Project# 31976

RE: Industrial Warehouse Trip Generation & Distribution – Tualatin, OR

SW 130th Avenue Driveway Location and
Correspondence with City of Tualatin

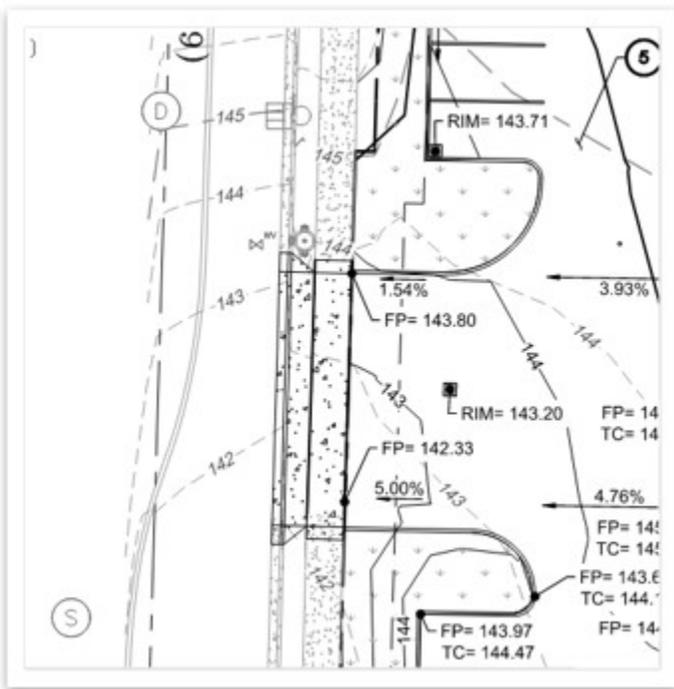
How will truck drivers be able to navigate the driveways to get to the loading docks on the north side of the building?

I noticed that at the south end of the property the land is below the street, with the street rising above the land as it moves north. Where do the grades actually match?

Trucks will have access to all driveways, and circulation will occur in a counterclockwise fashion, so vehicles entering 130th would circulate the parking lot on the front side of the buildings that face Leveton, and they would be able to get to the rear that way. Trucks accessing from Leveton would enter the site and also circulate counterclockwise. If there are very large vehicles entering the site they will be directed toward the driveways along Leveton.

Thanks for your reply. The proposed site plan is attached for your reference, and the driveway, as shown, is located approximately 127 feet from Leveton Drive (centerline-to-centerline). To answer your second question, the driveway has been located approximately at the location of where the grades are matching (refer to screen capture below and attached Civil layout). The intent of this design decision is to prevent water on the street from flowing onto/into the site.

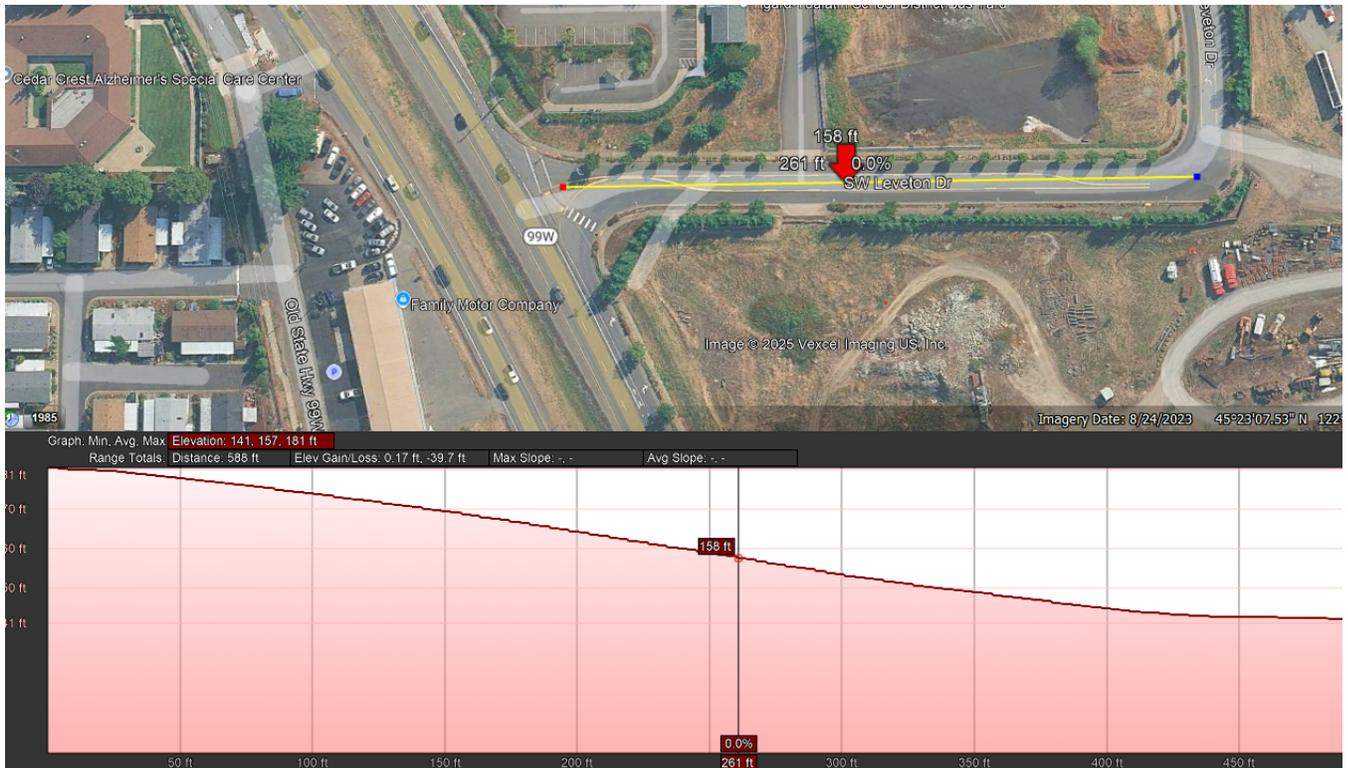
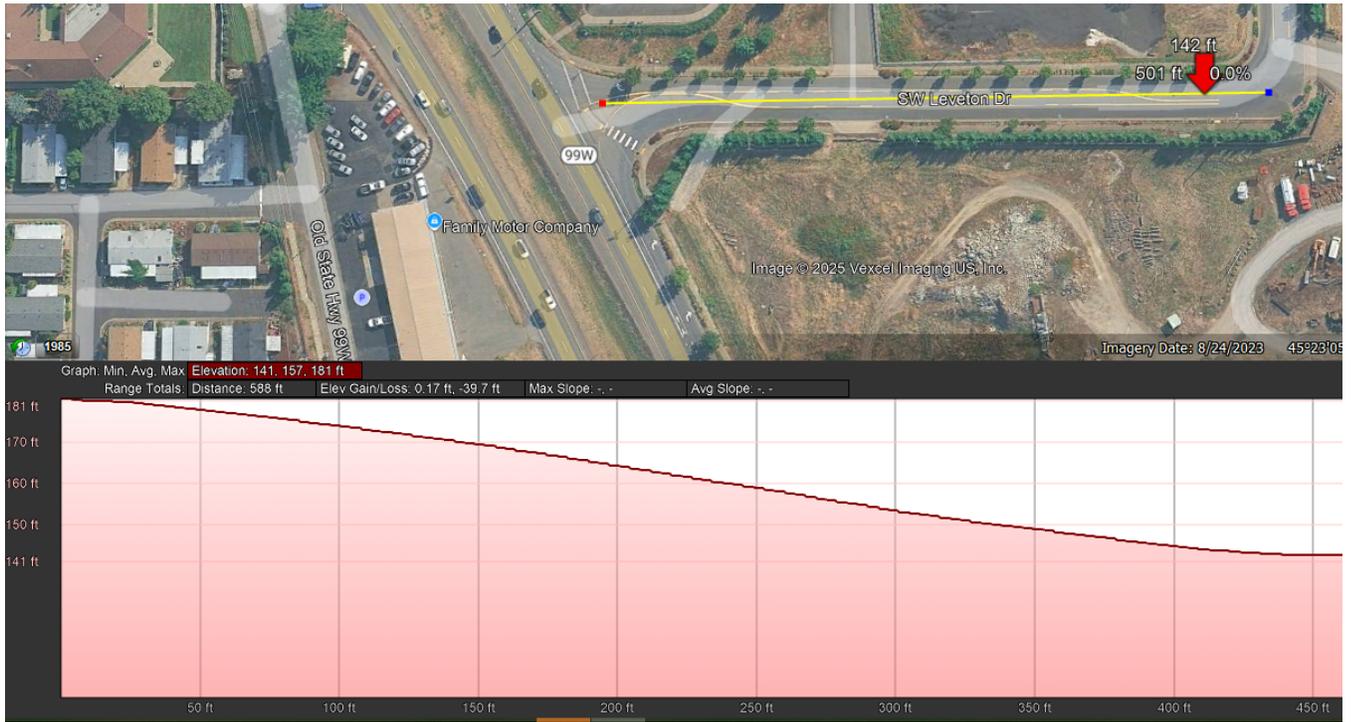
Please demonstrate how the proposed access configuration meets the appropriate codes and standards to be a safe access. It appears the access to 130th may need to slide north a bit (which it seems would match grade pretty well).

- The driveway location as proposed maximizes site distance to 99W and increases access spacing with the adjacent property to the north. Given the potential for simultaneous truck activity between the two sites, this separation provides less risk of overlapping conflicting movements.
- The roadway grade of Leveton Drive as it approaches 99W to the north is steep, and given the truck traffic to/from the site, would benefit from the lesser grade on the southern portion of Leveton (refer to images below)

- The proposed driveway location also maximizes the distance to the crest vertical curve (located approximately 100 feet south of 99W). The driveway would be located approximately 410 feet south of the crest vertical curve and 115 feet north of Leveton – refer to image below.
-

We recognize that the 115-foot distance to the elbow should provide sufficient sight distance to ensure safe maneuvers into and out of the driveway. While the posted speed along Leveton is 35mph, the 90-degree elbow will likely have a much lower operational speed. Please refer to the engineering analysis below to estimate the design speed for the 90-degree elbow.

Based on the *comfort speed formula* (ODOT Highway Design Manual Table 200-14), a design speed of 15 mph can be assumed for northbound traveling vehicles (shown in the image below, red arrow).

Assuming a 60' radius curve for the travel lane, a normal 2% cross slope, and a friction factor value based on a 25-mph design speed, the speed a vehicle could comfortably navigate that curve is 15mph:
